Tim North  
& Associates  
Limited

**Representations prepared on behalf of Holiday Extras Ltd as it relates to  
Gatwick Airport DCO Application**

**Deadline 2 - Tuesday 26 March 2024**

**PINS Reference No. TR020005**

DRAWING NO.  
**FIGURE E2.1a**

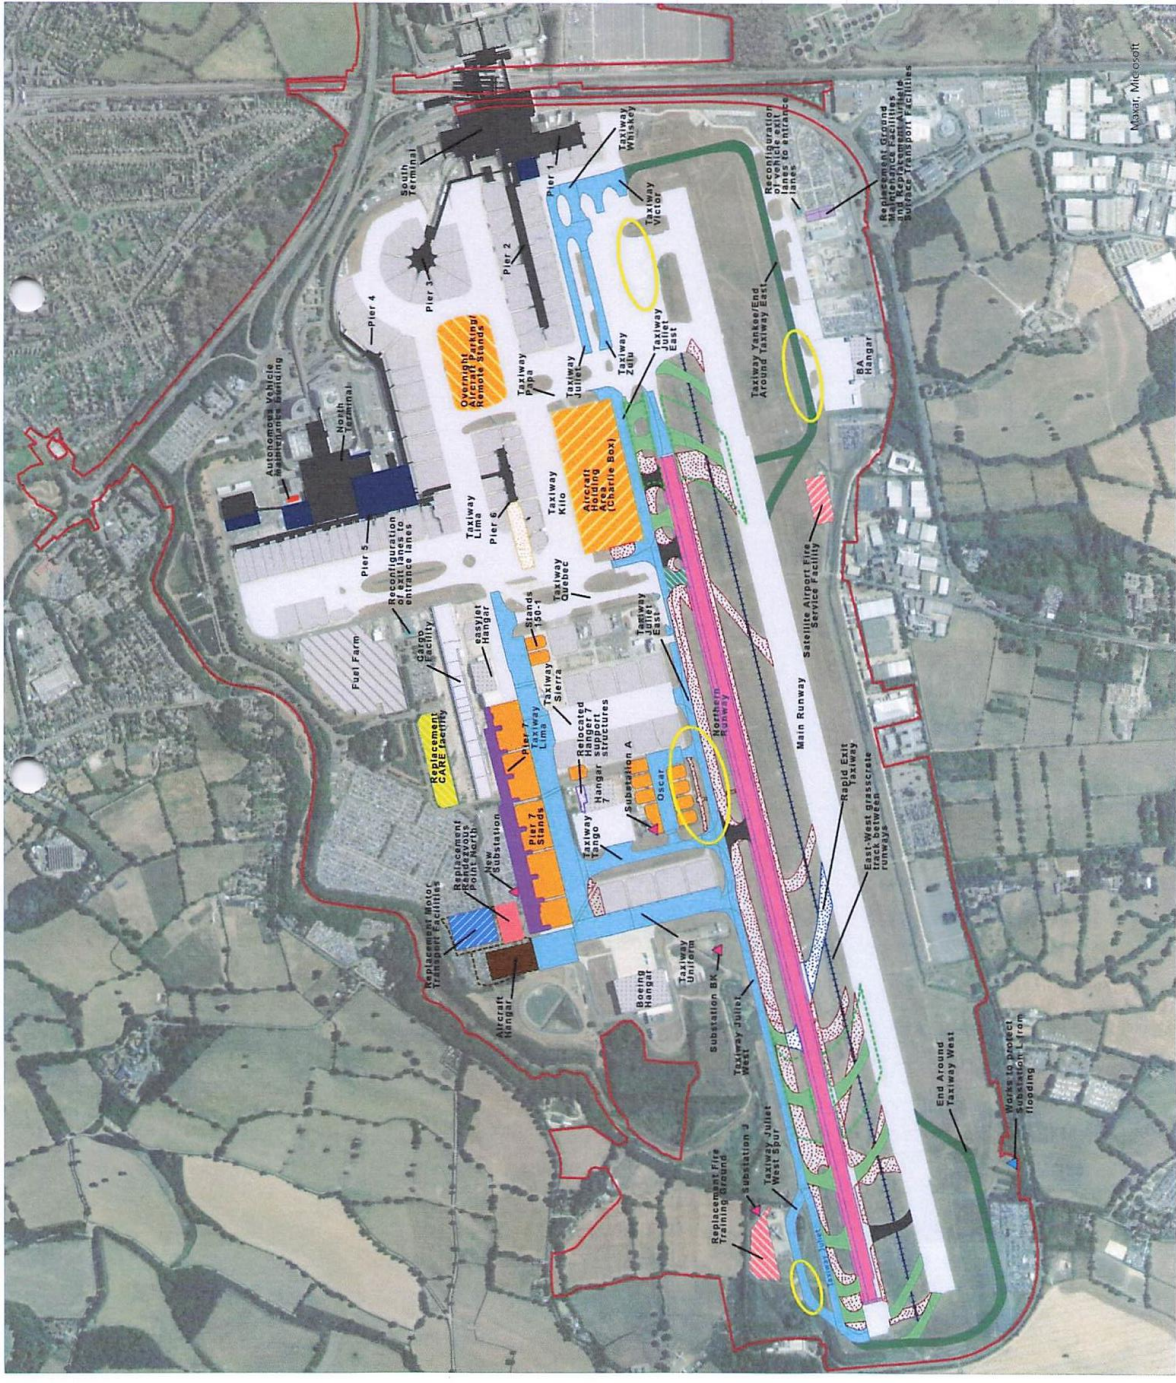
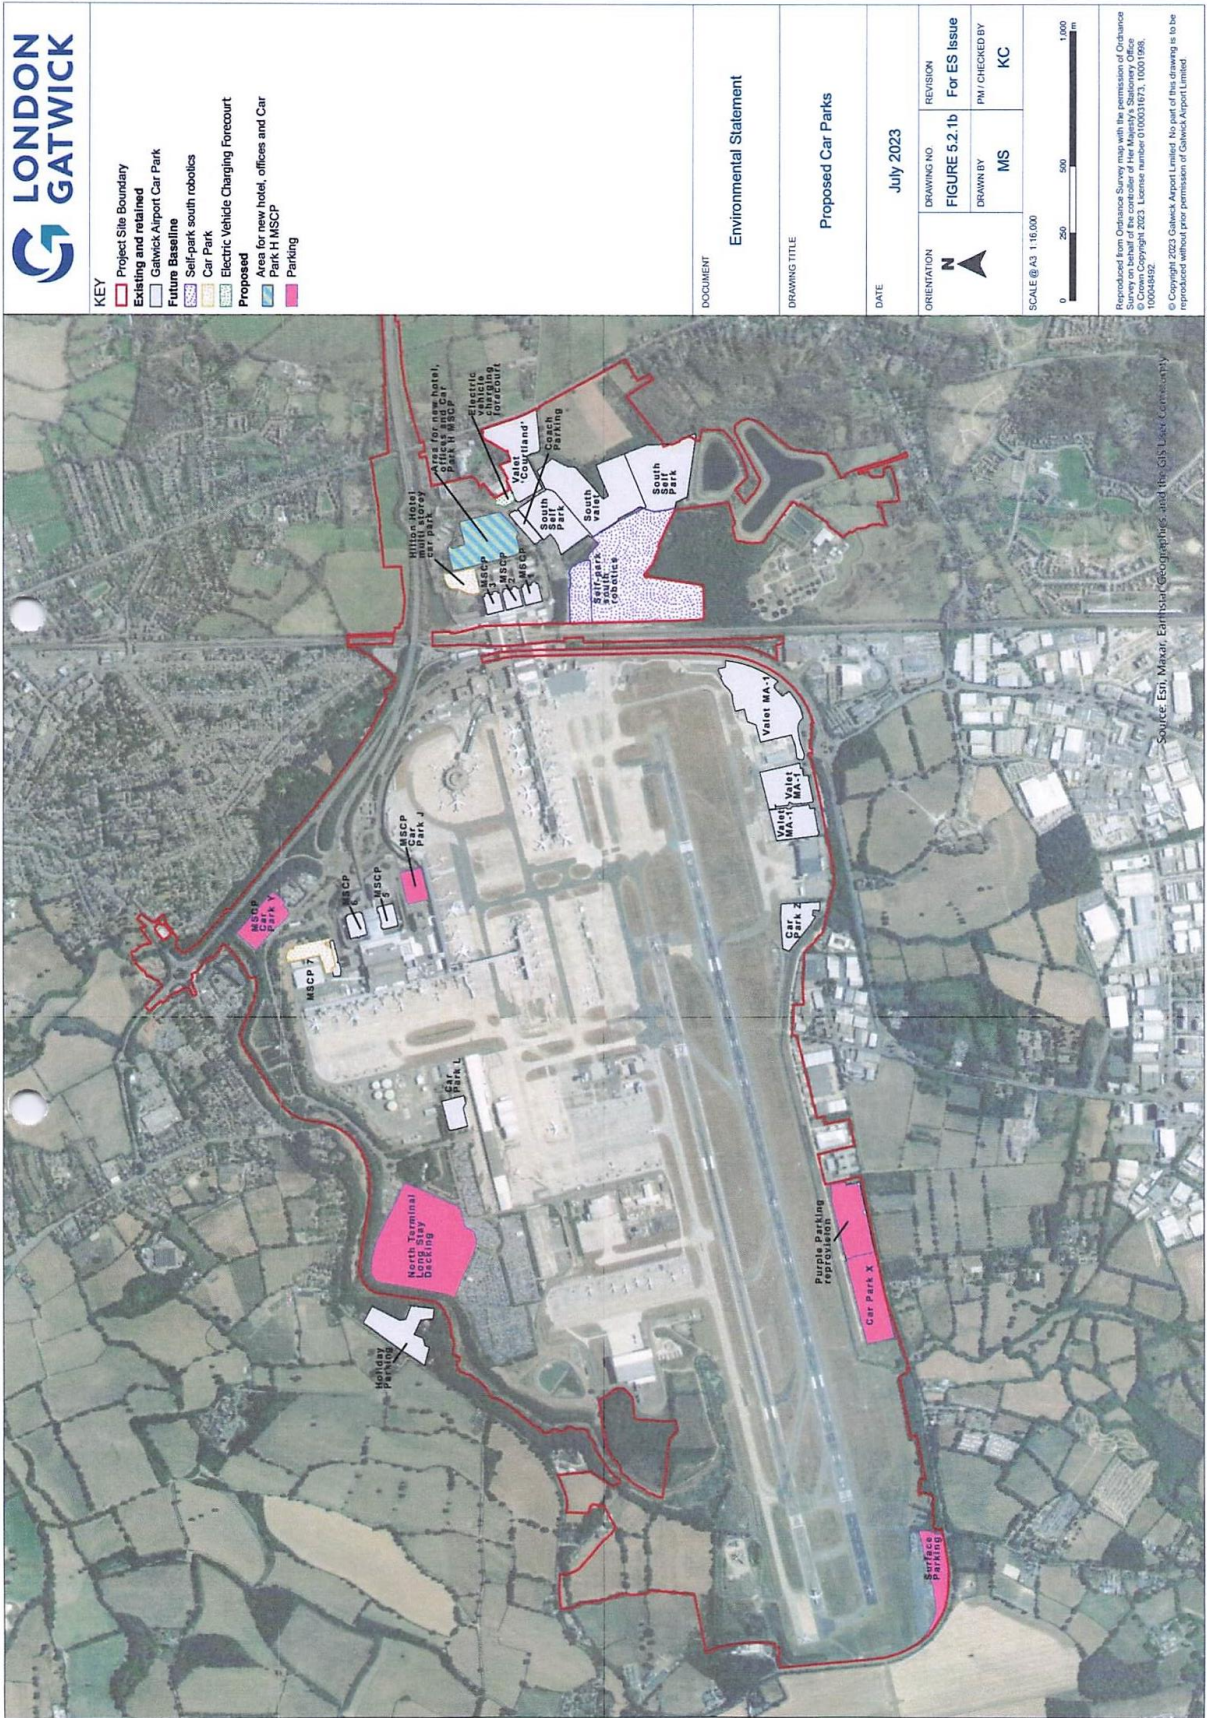
- 3.22 A comparison of the drawing indicated at page 14 of these representations, when considered in conjunction with Figure 5.2.1a of **Document AS-135** shows that the majority of the area comprising the Summer Special Car Park will be removed as a consequence of other developments associated with the Northern Runway project, and in particular the northerly extension of the current standby (emergency) runway and consequential extensions of taxiways Lima and Unicorn, together with the construction of Pier 7 and stands. Similarly, the extension of the Summer Special Long Term

passenger car park situated to the west of Zone W is to be removed as a consequence of the construction of a new hangar for Code E Aircraft; the relocated motor transport facility; and the Rendezvous Point North, the latter comprising a large area of hardstanding for external emergency vehicles (police, fire and ambulance services) required as a holding position in the event of a notified aerodrome incident.

- 3.27 All the passenger valet car parking taking place at the Flying Pan is to be removed, as the same area is to be redeveloped as a Central Area Recycling Enclosure (CARE) consisting of a biomass boiler, a waste processing building, together with a compound area and bin store, along with a flue extending to 50m in height above existing ground floor level. This is evident from an examination of Figure 5.2.1a comprising part of **Document AS-135**.
